CITY OF ALBUQUERQUE

RE: 1701 Soplo Rd SE
Permanent C.O. – Not Accepted
Engineer's Stamp Date: 03/14/19
Engineer's Certification Date: 08/18/21
Hydrology File: N23D001

Based on the Certification received 08/19/2021, this certification **is not** approved in support of Permanent Release of Occupancy by Hydrology. The following comments need to be addressed for approval of the above referenced project:

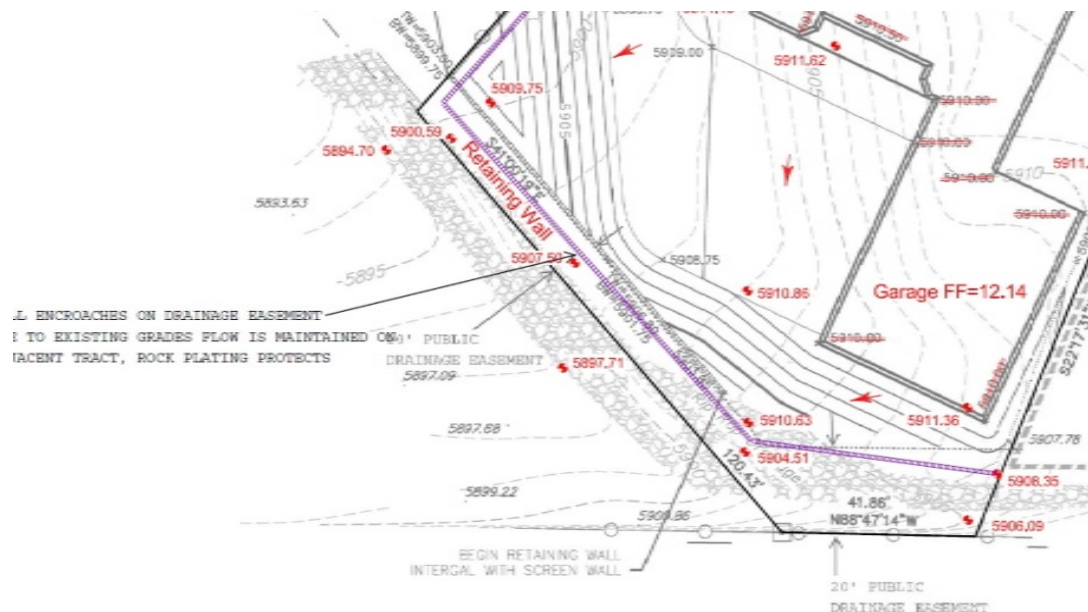
1. The retaining wall was built within both the 10 foot Drainage Easement along the Southwest property line and the 20 foot Drainage Easement along the South property line. The wall also was installed on top of the sour protection for the Four Hills Arroyo and some of it was removed with this installation. (See image below).

There are two possible solutions in order for Hydrology to issue an approval:

- a. The removal of the retaining wall within both Drainage Easements, re-establish the grades within the easement to pre-development conditions, and reestablish the sour protection for the Four Hills Arroyo. **Please note that the built location of the retaining wall was not approved by Hydrology.** During the wall permit process, the plan reviewer just looks to see if the Grading & Drainage Plan in the permit set was the approved plan.
- b. An engineering study to show that the remaining sour protection is able to handle the approximately 1200 cfs of the Four Hills Arroyo and get this approved by Hydrology. Then both Drainage Easements can be vacated through the Development Review Board (DRB). Once the vacation has been approved, then Hydrology will be able to approve this certification for Permanent Release of Occupancy.
